THE CITY OF KEY WEST

ADDENDUM NO. 1

EDWARD B. KNIGHT PIER BRIDGE SPAN 1 REPLACEMENT / ITB 18-029

July 05, 2018

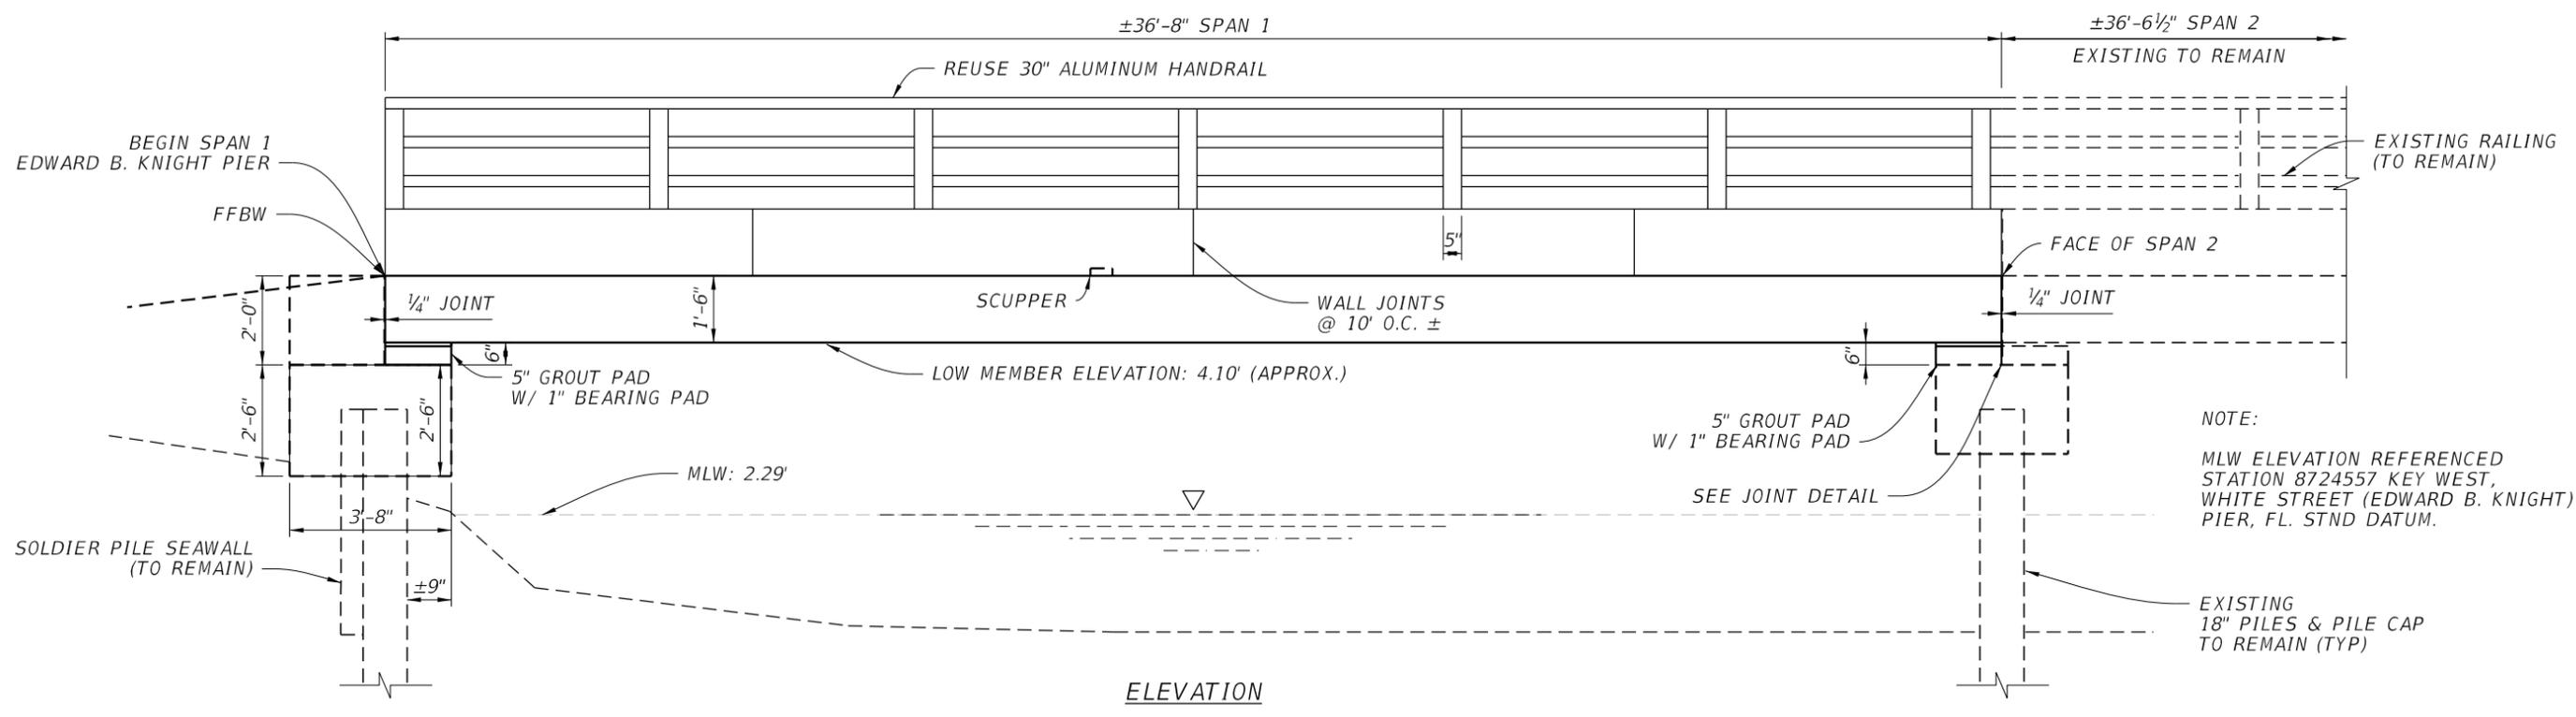
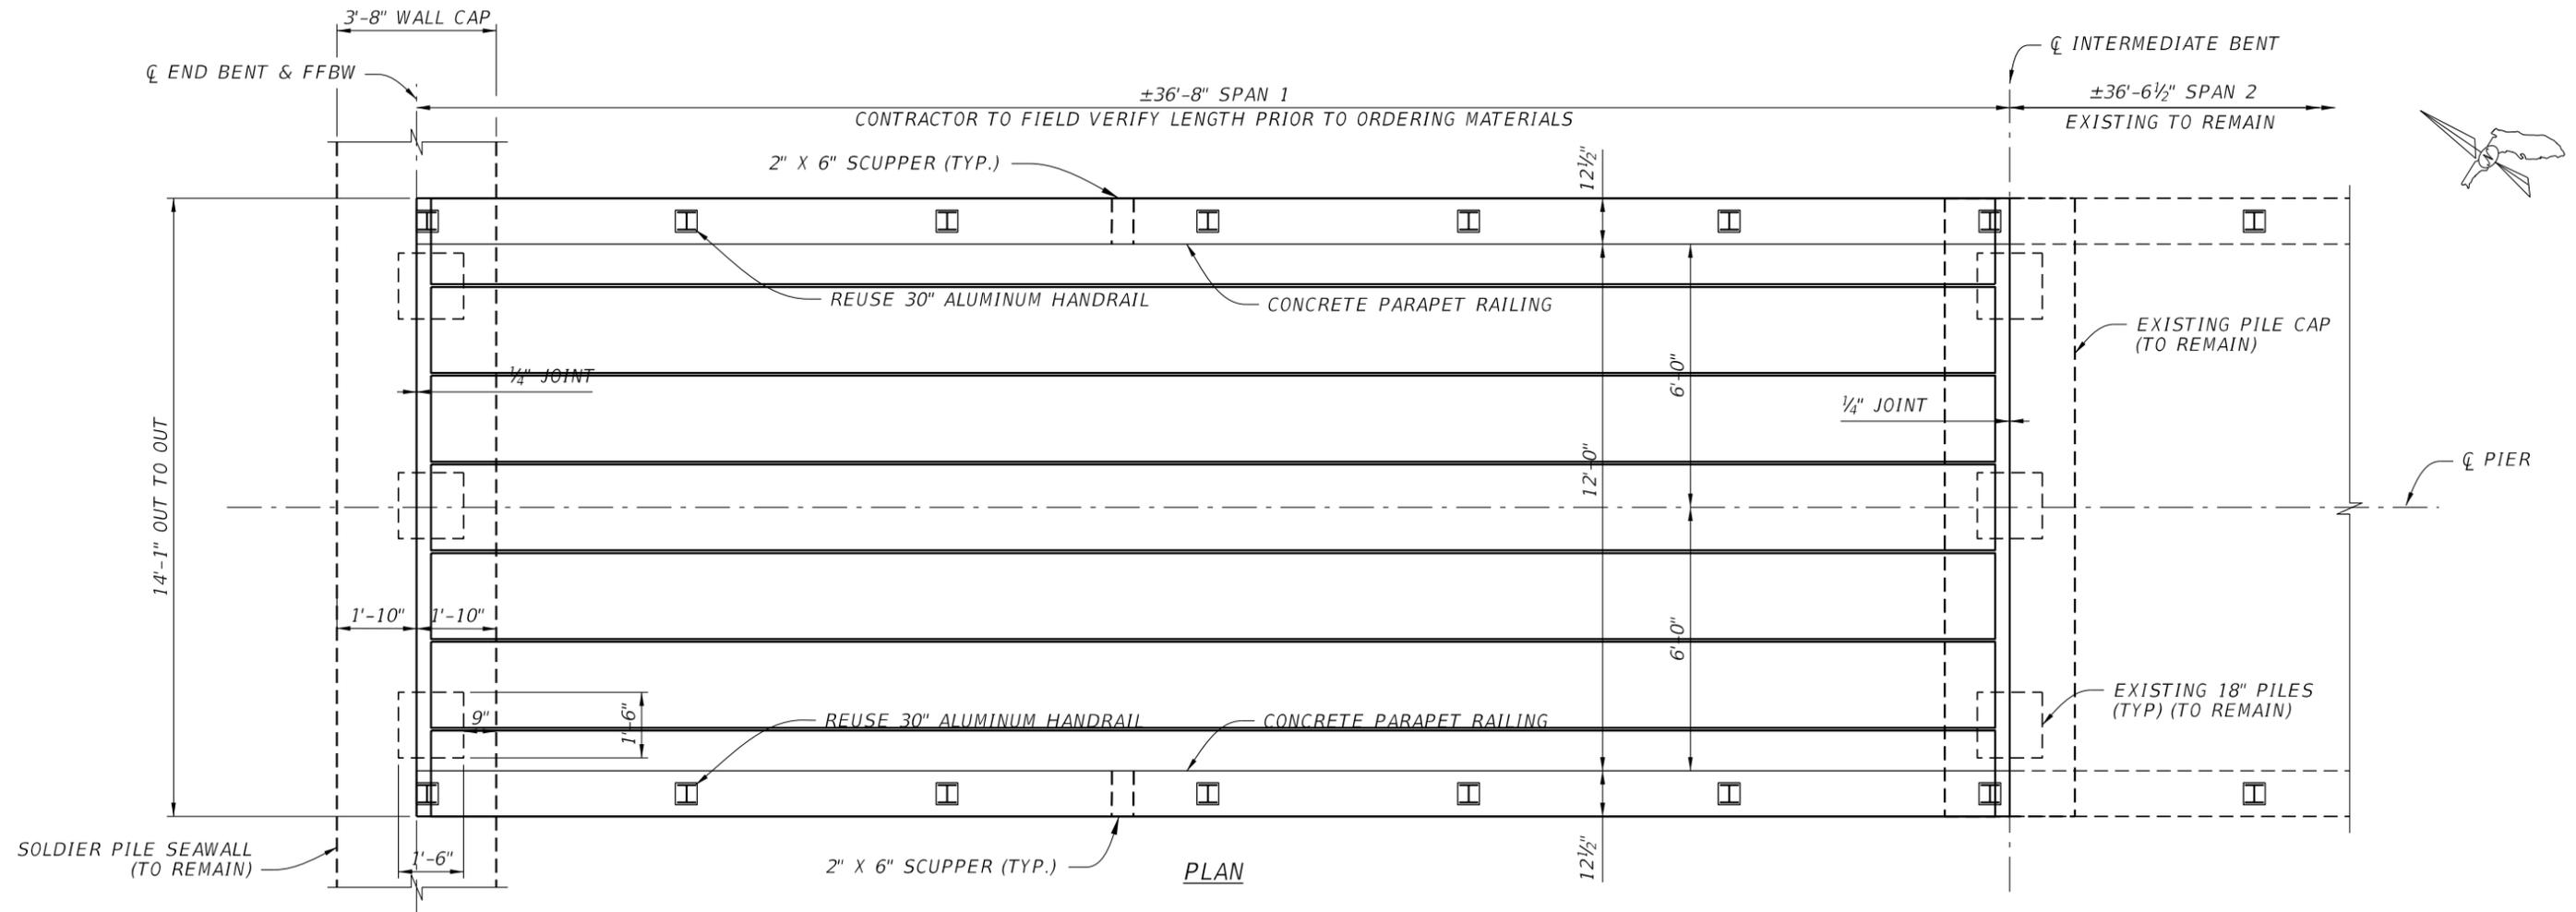
- 2.) Sheet B-02 General Notes; Utilities states “for locations of existing utilities, see plan and elevation sheet.” The aforementioned sheet has no utilities detailed on it. Please advise if currently electrical is running through existing structure. Provide any as-builts if possible. Please confirm that the disconnection & reconnection of the electrical power is part of this contract, and if so, provide details for that work including the location of the conduit and wires to be installed.
Response: The notes have been revised in Rev. 1 to clarify that existing conduits must be replaced; one 3 ½” PVC conduit is required in each curb.

The contractor is responsible for disconnecting the power supply to the bridge lighting, installation of two electrical conduits (one in each curb).

Conduits shall be continuously attached to the existing. Please note that the exact position of conduits and their size are unknown at this time. As-built drawings for the existing bridge are not available.

The contractor is to provide a separate line item for installation of two electrical grade sch 40 PVC conduits of 3-1/2" dia. (or smaller) in his bid.

The contractor is to provide a separate line item for removing and re-pulling existing electrical wiring for pier lights (size unknown).

Please see updated plans for approximate conduits location.

POWER IS TO BE DISCONNECTED BY A LICENSED ELECTRICIAN. IT IS TO BE EMBEDDED IN THE NEW CONCRETE POUR WITH NEW 3 1/2" SCHEDULE 40 PVC CONDUIT TO BE INSTALLED AND WIRES RE-PULLED.
